REMARKS

This paper is responsive to the Office Action mailed from the Patent and Trademark Office on November 18, 2002, which has a shortened statutory period set to expire February 18, 2003.

A0682 (XC-004)  
S/N: 09/898,321

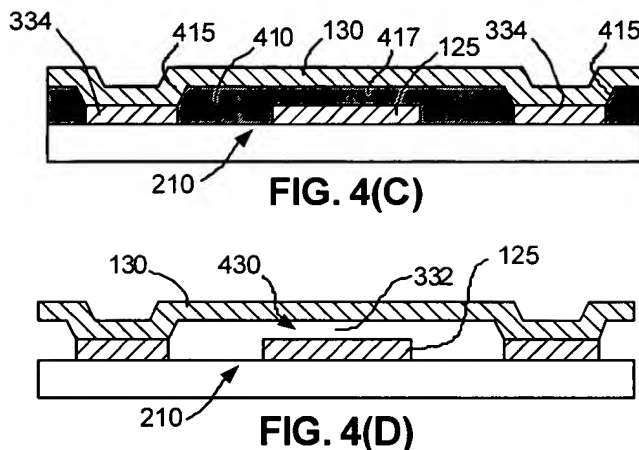
The above-quoted language is clearly supported in Applicants' Figs. 3 and 4(D). Note that, in the sequence illustrated in Applicants' Figs. 4(A) through 4(D) and described in Applicants' specification (i.e., paragraphs 0026 through 0030), a gate line 125 is formed on the upper surface of a substrate 400 (paragraph 0026), then a release material 410 is formed over the gate line 125 (paragraph 0027), then a data line 130 is formed on the release material 410 (paragraph 0029). Finally, as indicated in Applicants' Figs. 4(C) and 4(D) (reproduced below for reference), the release material 410 is etched to form an air-gap 302 extending between an upper surface of gate line 125 and a lower surface of data line 130:

Fig. 4(D) shows a subsequent release (etch) process during which release material is etched using a suitable etchant 430 in a manner that does not significantly damage data lines 130 and gate lines 125. Accordingly, release material portion 417 (see Fig. 4(C)) is removed from crossover location 210 such that an air-gap 302 is defined between data line 130 and gate line 125. (Paragraph 0030.)

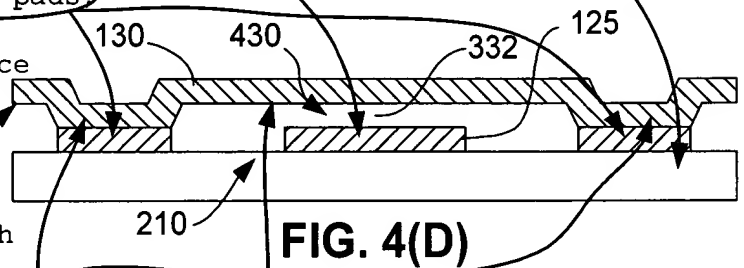
Finally, support for Claim 30 is indicated below with reference to Fig. 4(D).
